October 30, 2001

Subject: Arkansas Nuclear One - Unit 2
Docket No. 50-368
License No. NPF-6
Proposed Technical Specification Change Request Regarding Revised ANO-2 Pressure/Temperature and Low Temperature Overpressure Protection Limits for 32 Effective Full Power Years

Proposed Technical Specification Change Request Regarding Revised ANO-2 Pressure/Temperature and LTOP Limits for 32 EFPY

Figure 3.4-2A

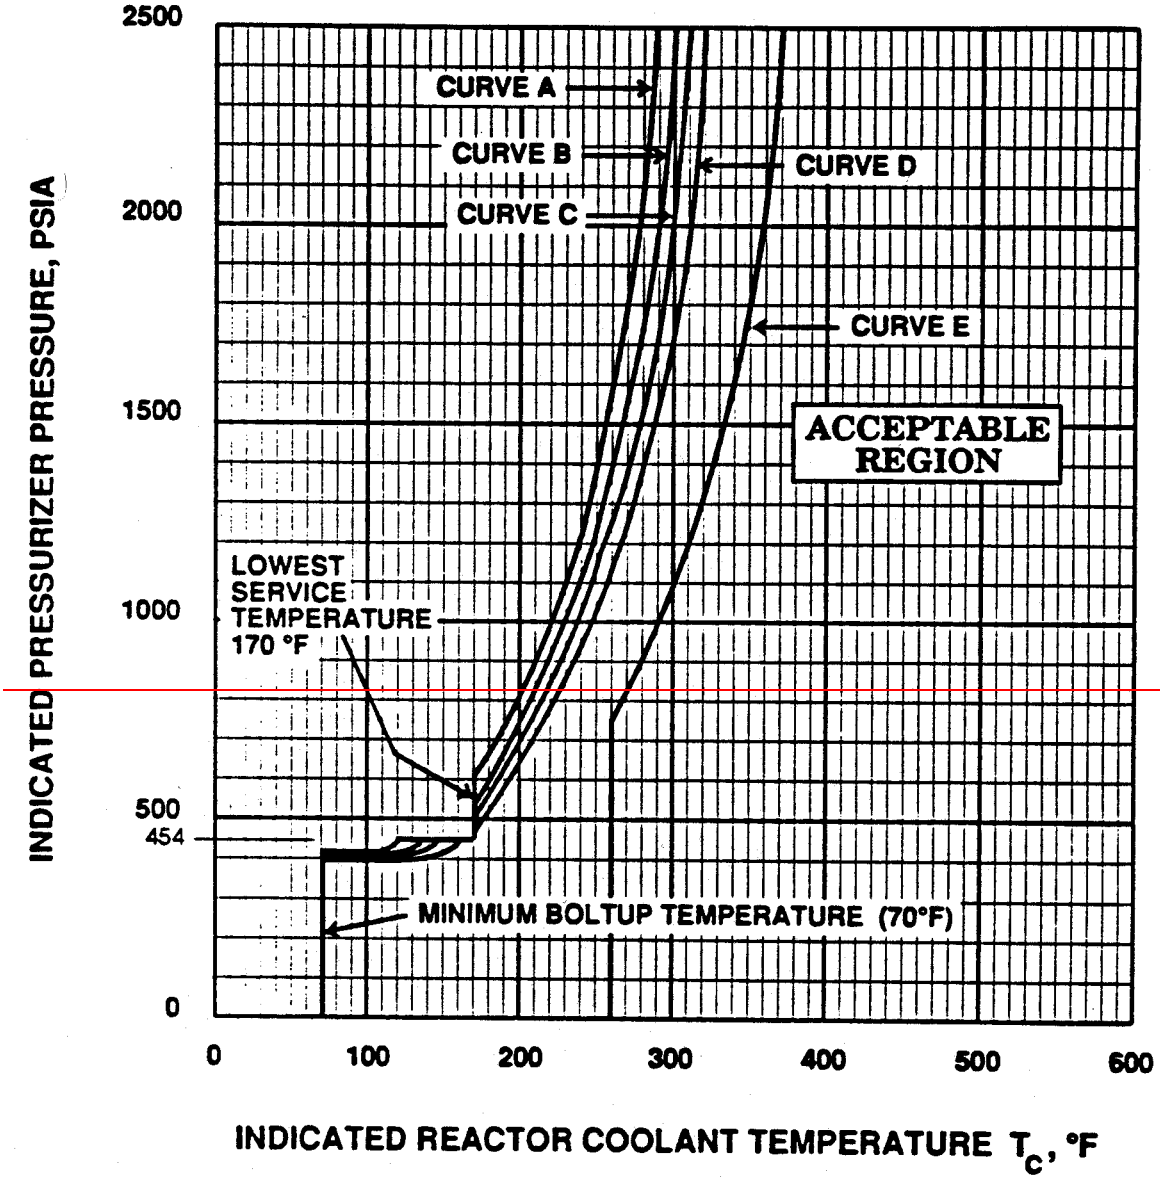
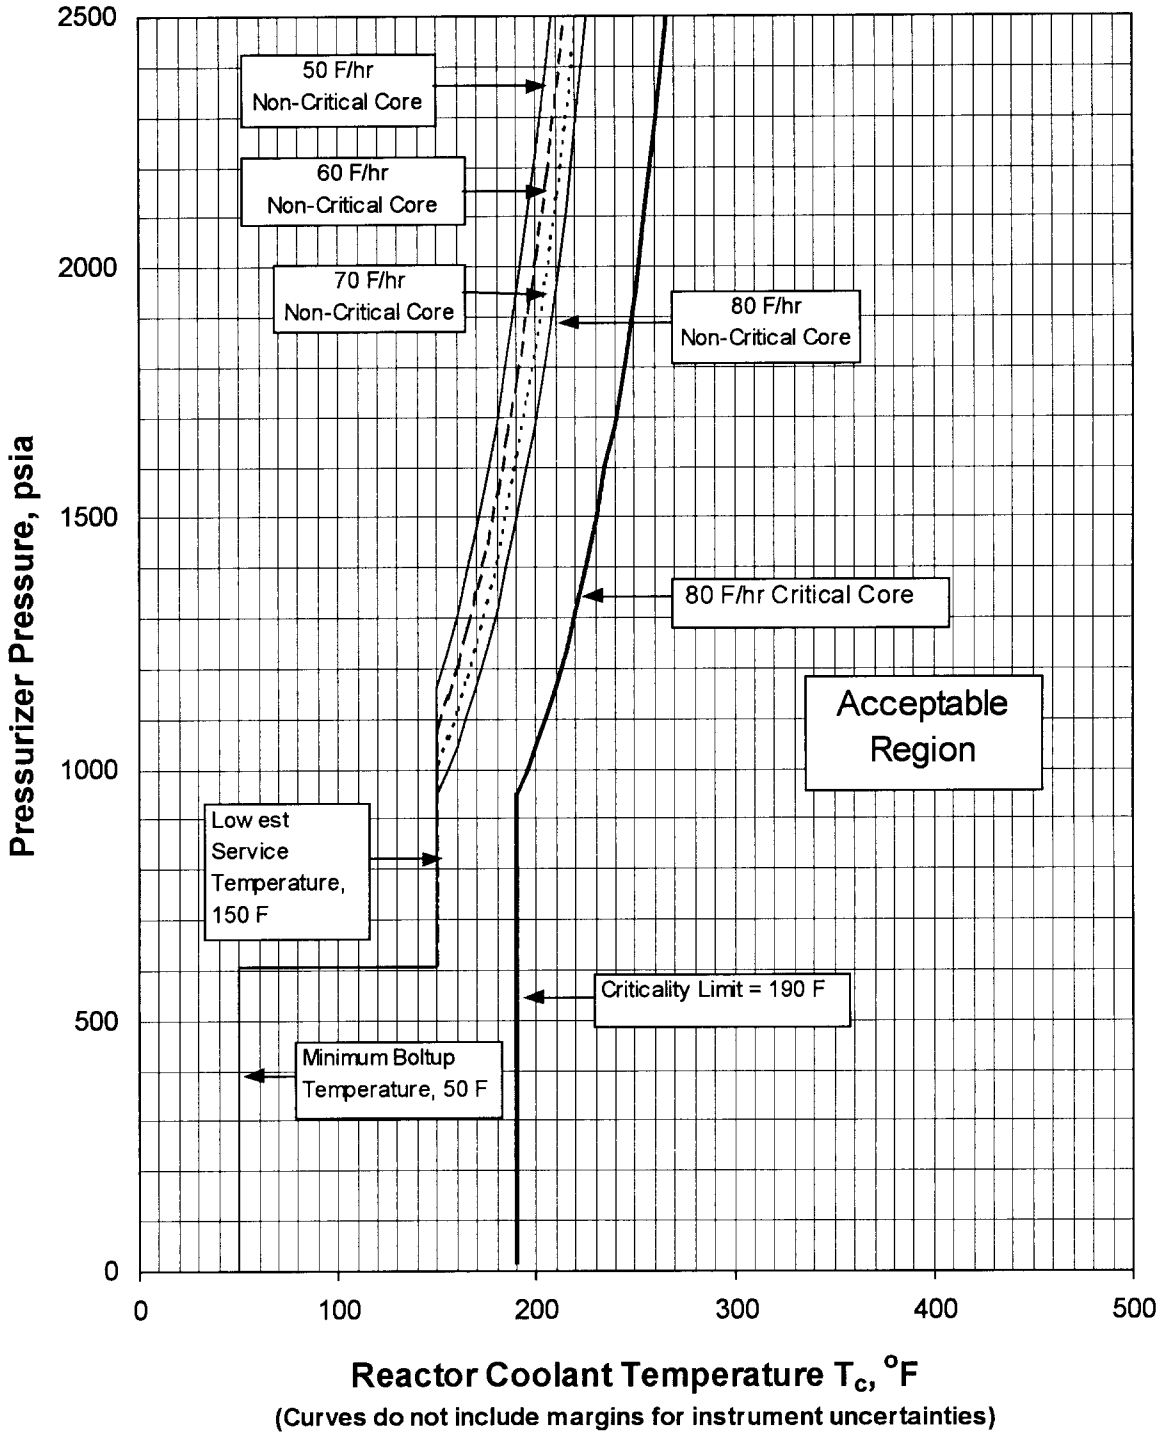
TS LCO 3.4.9.1a: The labeling on the curves as curves A, B, C, and D which represent heatup rates of 50°F, 60°F, 70°F, and 80°F per hour respectively, has been removed from Figure 3.4-2A. Therefore, this labeling scheme is no longer appropriate in the LCO.

TS Figures 3.4-2A, 3.4-2B and 3.4-2C have been revised to reflect new P/T limits for 32 EFPY for heatup/criticality, cooldown, and inservice hydrostatic test conditions, respectively.

(including criticality core limits) at 32 EFPY are provided on the revised TS Figure 3.4-2A. The criticality limit temperature is 190°F, which is based on the RT_{NDT} of the closure flange material (30°F) plus 160°F which is larger than the 175°F value that corresponds to the inservice hydrostatic test limit pressure of 2500 psig. Considering all the ramp and step cooldown transient scenarios, composite cooldown P/T limits for cooldown are shown in TS Figure 3.4-2B. The inservice hydrostatic test P/T limits are shown in TS Figure 3.4-2C. Acceptable pressure and temperature combinations for reactor operation are below and to the right of the pressure-temperature limit curves.

For normal heatup operation, TS Figure 3.4-2A, four ramped heatup transient conditions are considered in the evaluation. These transient conditions are simulated by increasing the reactor coolant system (RCS) cold leg temperature from 50°F to 560°F at constant rates of 50, 60, 70 and 80°F/hr. The inservice hydrostatic test condition contained in TS Figure 3.4-2C is also evaluated using the RCS cold leg temperature ranges, at a ramp rate of 10°F/hr.

a. A maximum heatup of 50°F, 60°F, 70°F or 80°F in any one hour period in accordance with ~~curves A, B, C or D, respectively, in~~ Figure 3.4-2A.

Figure 3.4-2B

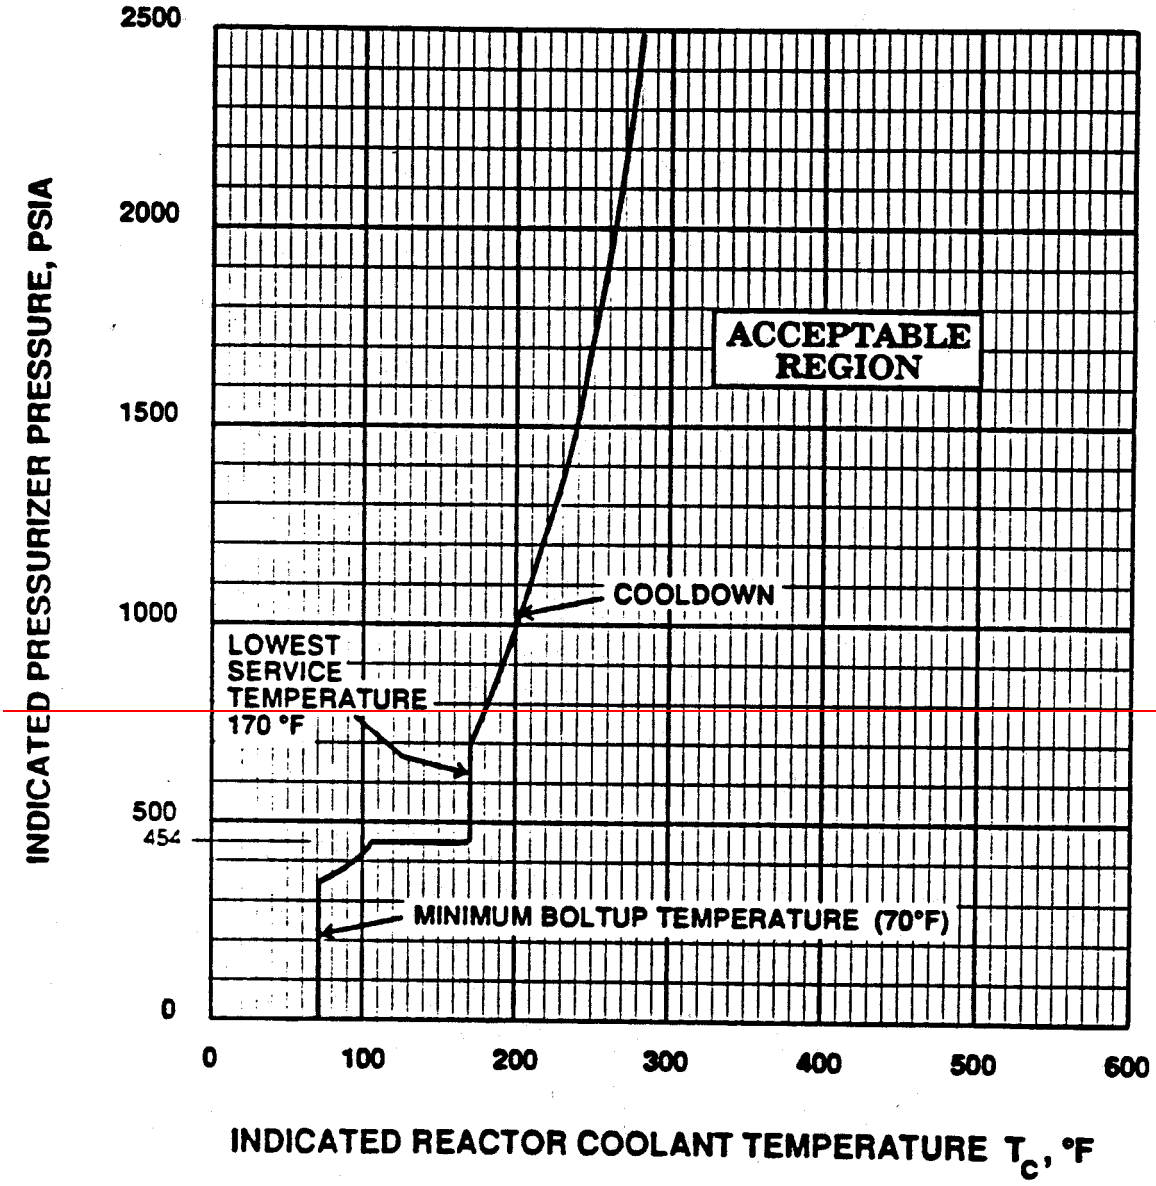
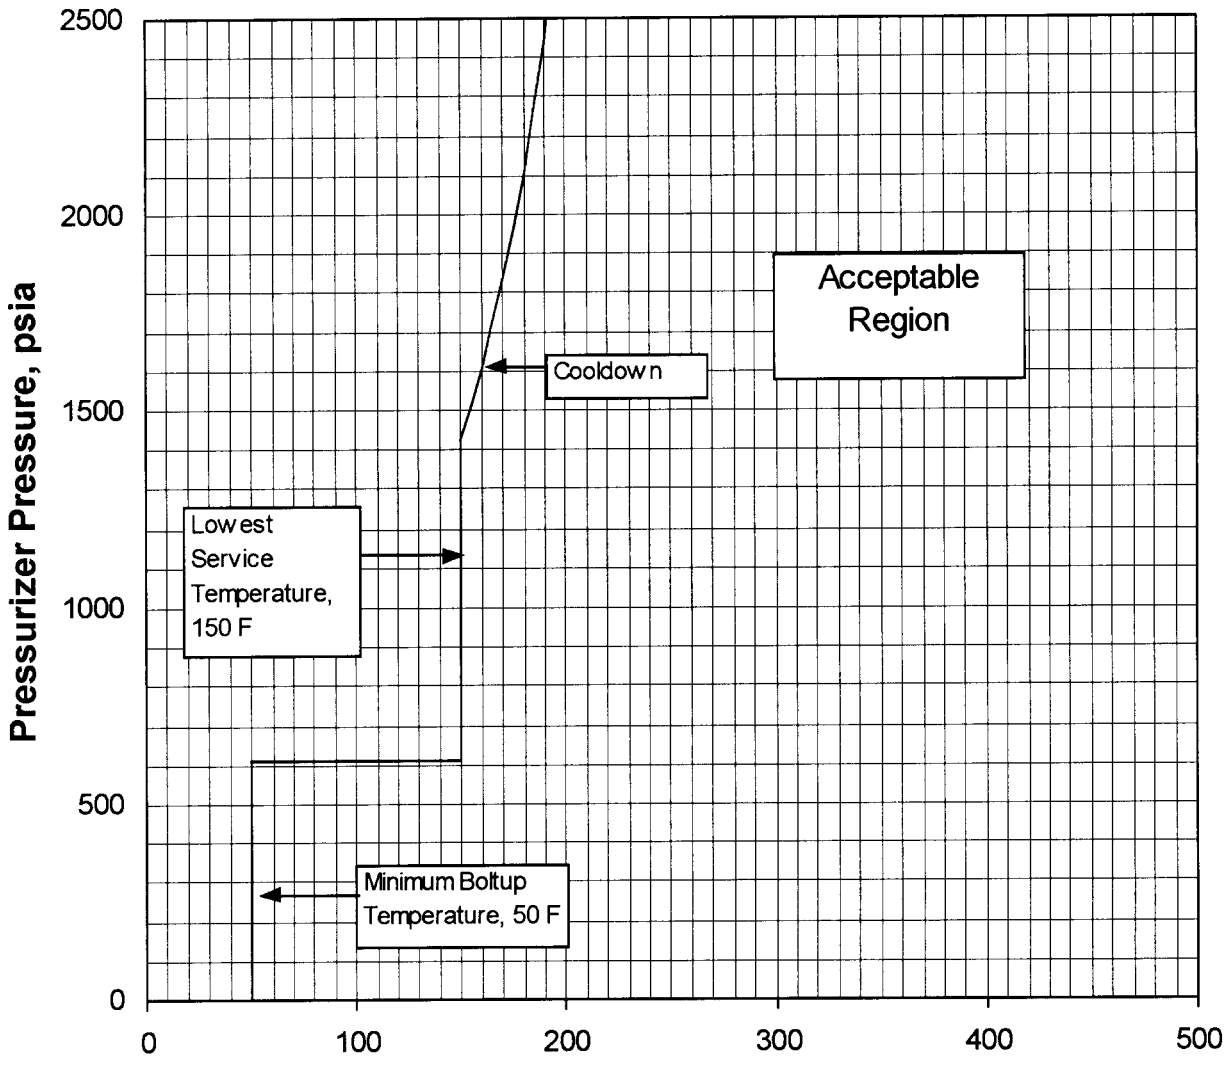
TS LCO 3.4.9.1b: For normal cooldown operation (Figure 3.4-2B) the following temperature dependant rates for ramped (constant) and stepped cooldown transients were used in the evaluation and are reflected in the TS LCO. These analyses are the same as those currently used except that no instrument uncertainty is being applied.

For normal cooldown operation, Figure 3.4-2B, the following temperature dependant rates for ramped and stepped cooldown transients are considered in the evaluation. Except for these cooldown rates not including a margin for instrument uncertainty they are identical to those used in the current TS P/T curves contained in the TSs. The assumptions also include that only two RCPs are in operation while in the LTOP region of the curves consistent with the current TSs.

$200\ ^{o}F < T_c$	100^{o}F/hr (constant) or 50^{o}F in any half hour period (step)
$120\ ^{o}F \le T_c \le 200\ ^{o}F$	60^{o}F/hr (constant) or 30^{o}F in any half hour period (step)
$T_c < 120\ ^{o}F$	25^{o}F/hr (constant) or 12.5^{o}F in any half hour period (step)

Figure 3.4-2C
ARKANSAS NUCLEAR ONE UNIT 2
INSERVICE HYDROSTATIC TEST CURVE - 21 EFPY
REACTOR COOLANT SYSTEM PRESSURE/TEMPERATURE LIMITS

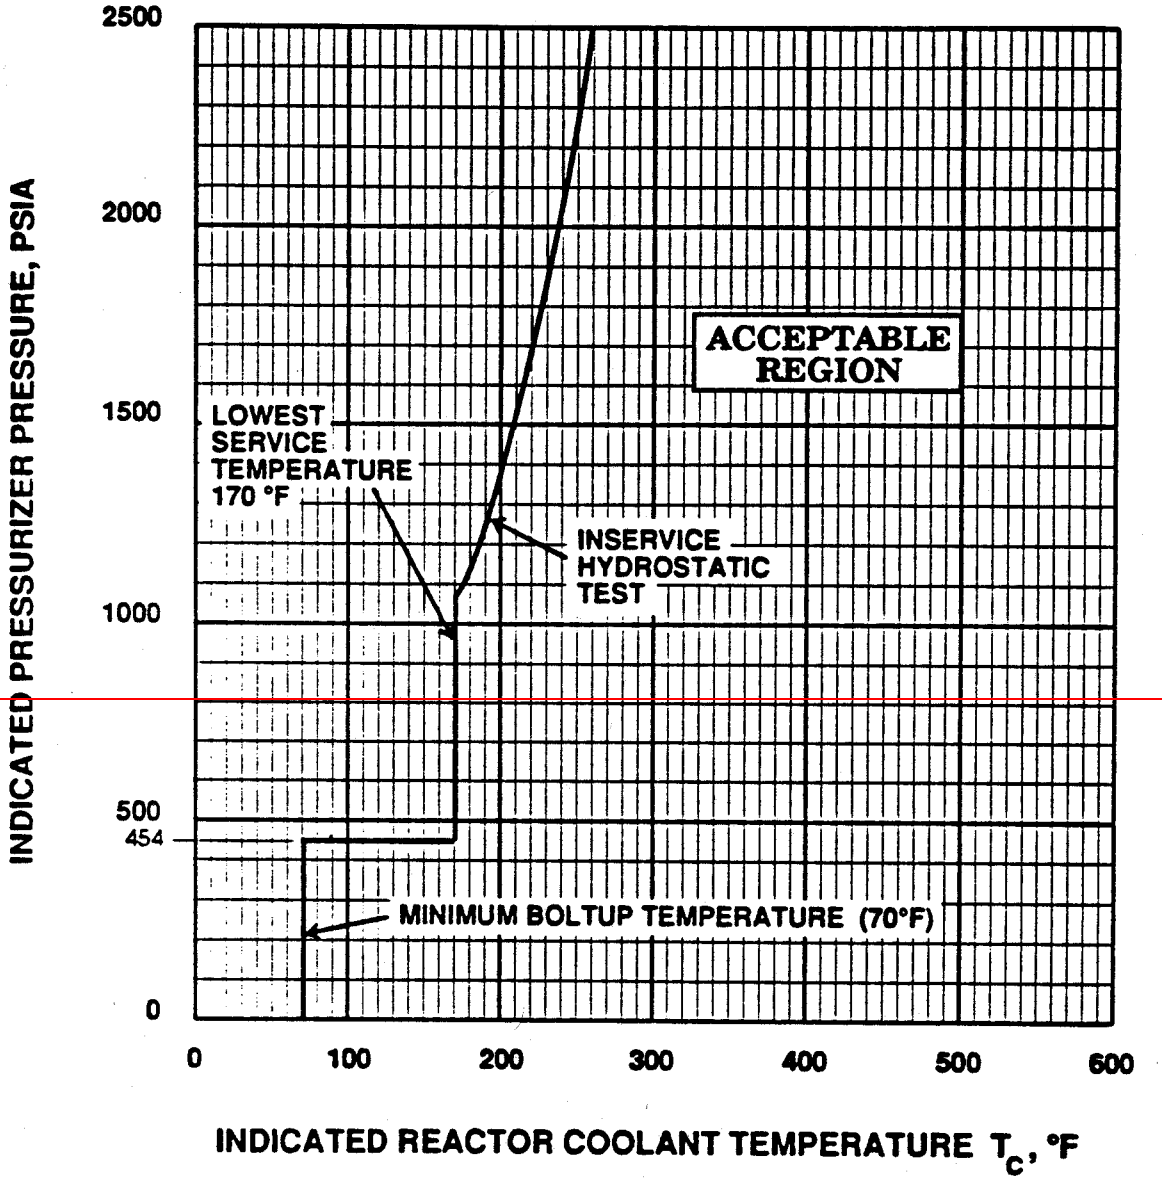
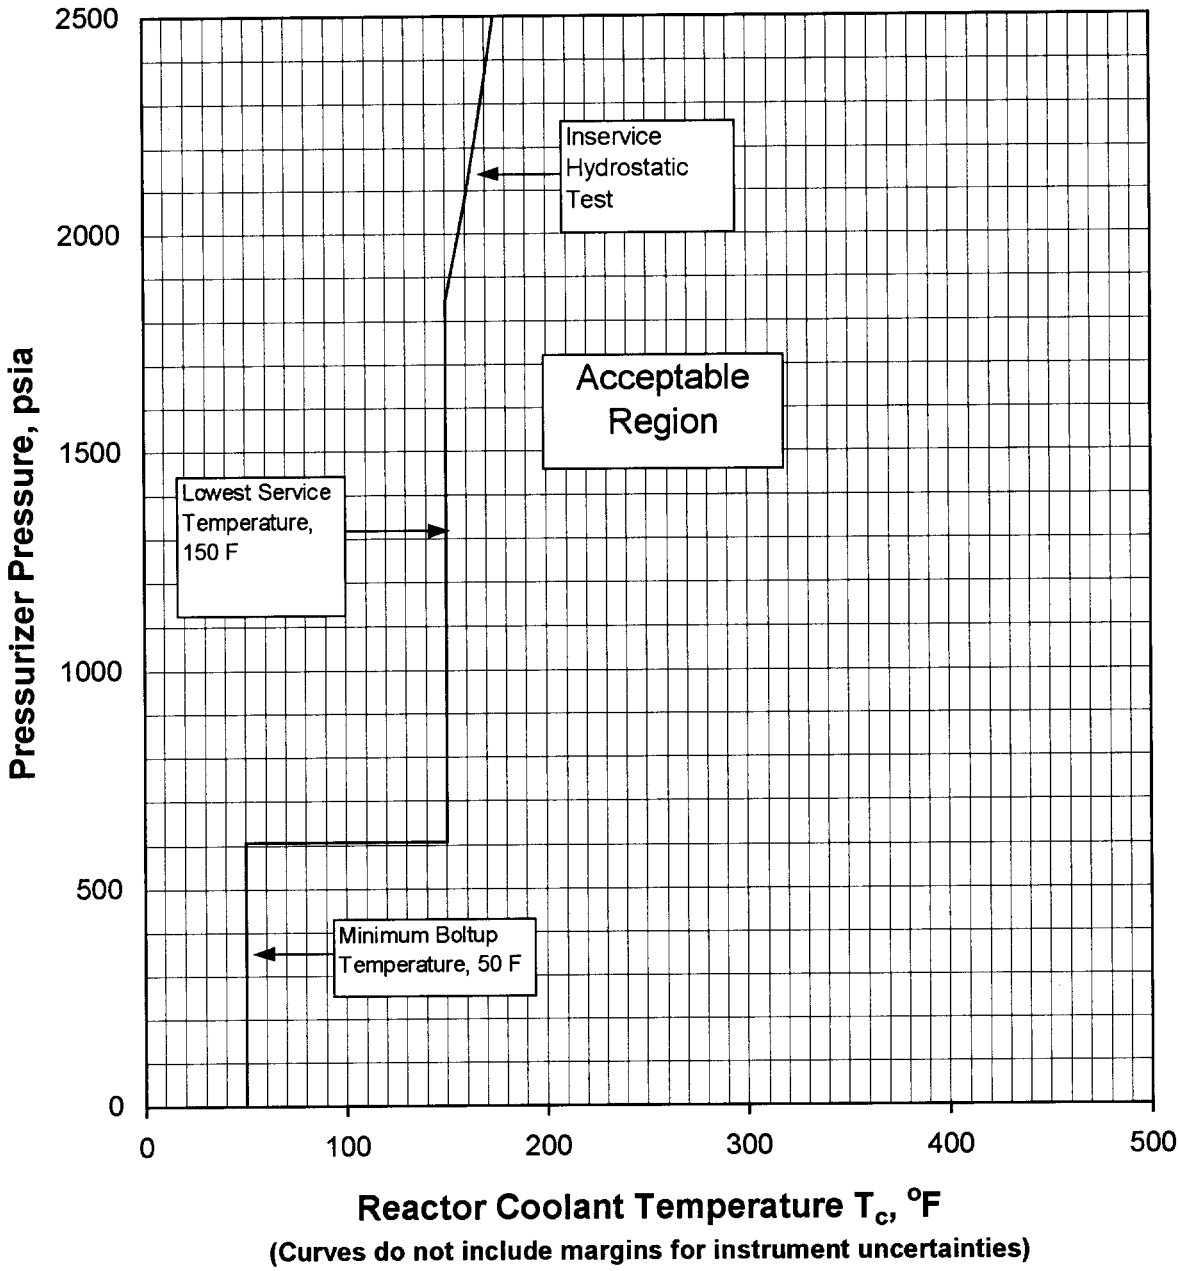
Both 10CFR Part 50, Appendix G and ASME Code Section III, Appendix G, require the development of pressure/temperature limits which are applicable to inservice hydrostatic tests. The minimum temperature for the inservice hydrostatic test pressure can be determined by entering the curve at the test pressure ~~(1.1 times normal operating pressure)~~ and locating the corresponding temperature. This curve is shown for ~~21~~32 EFPY on Figure 3.4-2C.
